UNITED STATES PATENT AND TRADEMARK OFFICE

Office Action Summary	Application No. 10/690,317	Applicant(s) KIM ET AL.	
	Examiner Seth Barnes	Art Unit 2822

DETAILED ACTION

**FIG. 4**

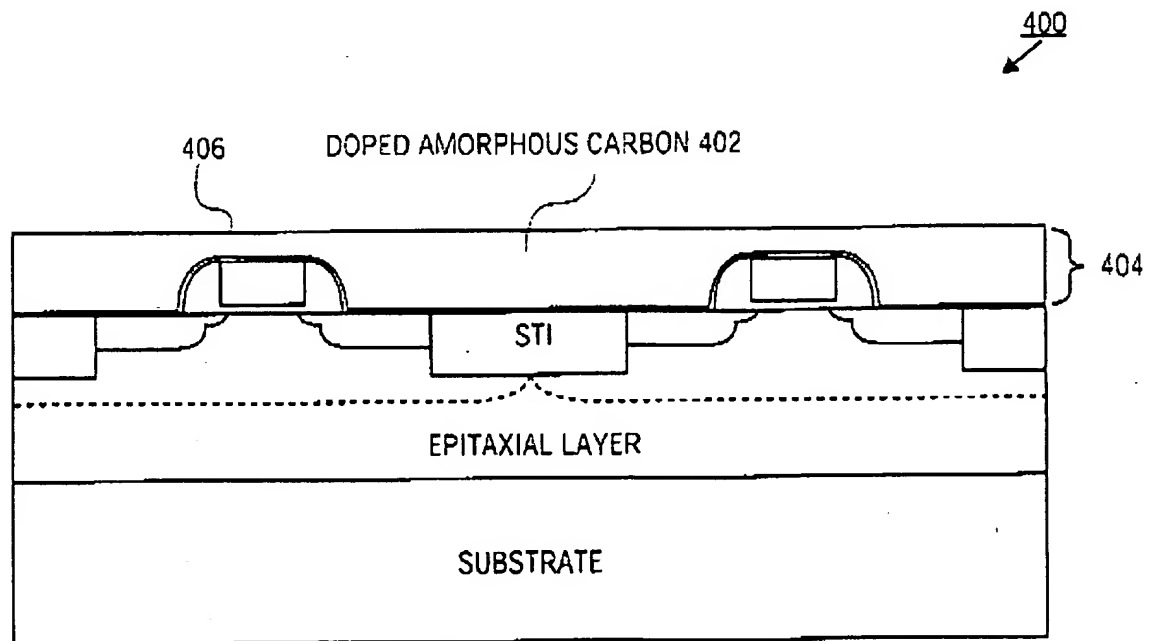
Regarding **claims 19 and 21** rejected under 35 U.S.C. §103(a) as being unpatentable over Park et al. (U.S. 5,296,400) in view of Ravi et al. (U.S. 6,548,313), the Applicant states on page 4, "Ravi et al. does not teach that the planarized amorphous carbon filler is a continuous layer residing between and abutting to the adjacent transistor gate structures as presently claimed in the instant invention (see Fig. 4 and 5A)." The Applicant further states on page 5, "There is no indication that the teachings of Park et al. and Ravi et al. are combinable and even if they are combinable, the combination thereof would not result in a 'planarized amorphous carbon filler that is a continuous layer residing between and abutting to the adjacent transistor gate structures' as presently claimed in the instant invention, but instead might result in a planarized amorphous carbon filler that is 'not' a continuous layer residing between and abutting to adjacent gate structures as Fig. 4 and 5A of Ravi et al. demonstrates."

The Examiner respectfully disagrees. In Fig. 4 (shown below) the planarized amorphous carbon filler (**404, 402**) is a continuous layer residing between and abutting to the adjacent transistor gate structures. In response to applicant's argument that there is no suggestion to combine the references, the examiner recognizes that obviousness can only be established by combining or modifying the teachings of the prior art to

Regarding **claim 21** rejected under 35 U.S.C. §103(a) as being unpatentable over Wei et al. (U.S. 6,423,645) in view of Ravi et al. (U.S. 6,548,313), the Applicant states on page 6, "Ravi et al. does not teach that the planarized amorphous carbon filler is a continuous layer residing between and abutting to the adjacent transistor gate structures as presently claimed in the instant invention (see Fig. 4 and 5A)." The Applicant further states on pages 6 and 7, "There is no indication that the teachings of Wei et al. and Ravi et al. are combinable and even if they are combinable, the combination thereof would not result in a 'planarized amorphous carbon filler that is a continuous layer residing between and abutting to the adjacent transistor gate structures' as presently claimed in the instant invention, but instead might result in a planarized amorphous carbon filler that is 'not' a continuous layer residing between and abutting to adjacent gate structures as Fig. 4 and 5A of Ravi et al. demonstrates.

The Examiner respectfully disagrees. In Fig. 4 (shown above) the planarized amorphous carbon filler (**404, 402**) is a continuous layer residing between and abutting to the adjacent transistor gate structures. In response to applicant's argument that there is no suggestion to combine the references, the examiner recognizes that obviousness can only be established by combining or modifying the teachings of the prior art to produce the claimed invention where there is some teaching, suggestion, or motivation to do so found either in the references themselves or in the knowledge generally available to one of ordinary skill in the art. See *In re Fine*, 837 F.2d 1071, 5 USPQ2d 1596 (Fed. Cir. 1988) and *In re Jones*, 958 F.2d 347, 21 USPQ2d 1941 (Fed. Cir. 1992). In this case, it would have been obvious to a person of

Regarding **claim 20** rejected under 35 U.S.C. §103(a) as being unpatentable over Park et al. (U.S. 5,296,400) in view Ha (U.S. 6,451,708) and Ravi et al. (U.S. 6,548,313), the Applicant states on page 8, "Ravi et al. does not teach that the planarized amorphous carbon filler is a continuous layer residing between and abutting to the adjacent transistor gate structures as presently claimed in the instant invention (see Fig. 4 and 5A)." The Applicant further states on page 8, "There is no indication that the teachings of Park et al., Ha and Ravi et al. are combinable and even if they are combinable, the combination thereof would not result in a 'planarized amorphous carbon filler that is a continuous layer residing between and abutting to the adjacent transistor gate structures' as presently claimed in the instant invention, but instead might result in a planarized amorphous carbon filler that is 'not' a continuous layer residing between and abutting to adjacent gate structures as Fig. 4 and 5A of Ravi et al. demonstrates."

The Examiner respectfully disagrees. In Fig. 4 (shown above) the planarized amorphous carbon filler (**404, 402**) is a continuous layer residing between and abutting to the adjacent transistor gate structures. In response to applicant's argument that there is no suggestion to combine the references, the examiner recognizes that obviousness can only be established by combining or modifying the teachings of the prior art to
